**Board of Zoning Appeals Meeting
September 26, 2023**

CASE NUMBER:	V-23-0010
PROPERTY LOCATIONS:	9165 Nesbit Ferry Road and 26 Nesbit Place
CURRENT ZONING:	TR (Townhouse Residential District) Conditional
PARCEL SIZE:	4.25 Acres
PROPERTY OWNERS:	The Park at Nesbit Place Owners Association Inc. and Luis Garcia
VARIANCE REQUEST:	49-foot encroachment into the 75-foot stream buffer to replace and extend existing timber steps and retaining wall
STAFF RECOMMENDATION:	APPROVAL WITH CONDITIONS

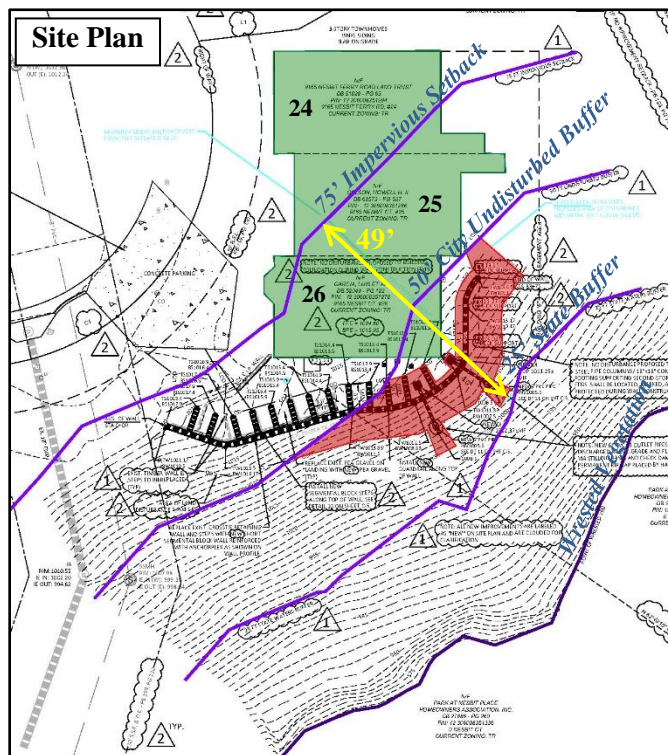
The Applicant is requesting to encroach 49 feet into the 75-foot stream buffer to replace an existing timber wall and steps with new segmental blocks and extension of the wall for soil stabilization. The proposal will result in approximately 584 square feet of land disturbance (shown in red) and 148 square feet of impervious surface in the City's stream buffer. However, the net increase of impervious surface in the stream buffer would only be 86 square feet, as 62 square feet of timber steps and wall already exist. The Applicant has not proposed any new land disturbance within the State's 25-foot stream buffer.

In order to offset stormwater and environmental impacts associated with the proposed encroachment into the stream buffer, the Applicant proposes to plant 2 small trees, 12 shrubs, and 49 ground cover on-site.

- 1) The proposed development shall not exceed the following encroachments, as shown on the site plan received by the Community Development Department on August 21, 2023:
 - a. 49 linear feet of encroachment into the stream buffer;
 - b. 148 square feet of total impervious surface within the stream buffer; and
 - c. 584 square feet of disturbance within the City's 50-foot undisturbed stream buffer.

- 2) A vegetative planting plan shall be submitted to the Community Development Department for approval by the Deputy Director, prior to the issuance of a building permit. Said plan shall be consistent with the mitigation plan received by the Community Development Department on August 21, 2023. The final vegetative planting shall pass City inspection prior to the issuance of a Certificate of Completion for the retaining wall.
